Access Compliance Report

Public Rights-of-Way

Intersection ID: 7938	Main Street: N_HOSKINS_RD	Cross Street: THOMPSON_ST	Location: SE
ADA ID: 4A7D3507B738	Ramp Type: Directional1	Initial Pass/Fail: Fail	Overall Compliance: No
Severity Score: 13.75			
Codes/Mitigation Info/Possible Solution		Field Measurements/Component Compliance

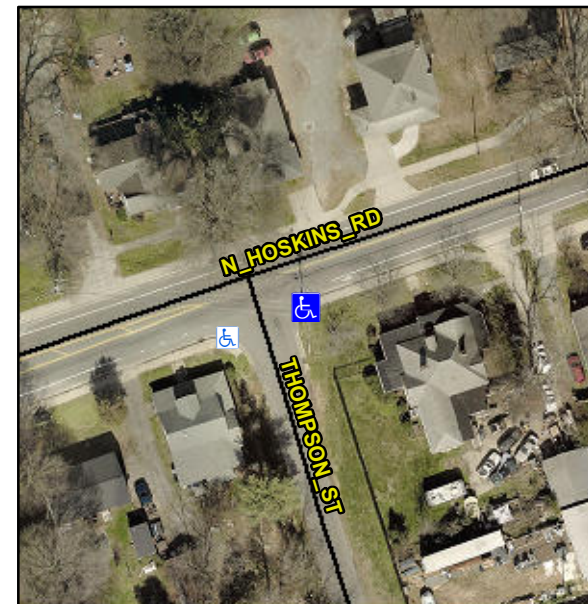
Remove & Replace Entire Ramp.

R304.2.2, R304.5.3
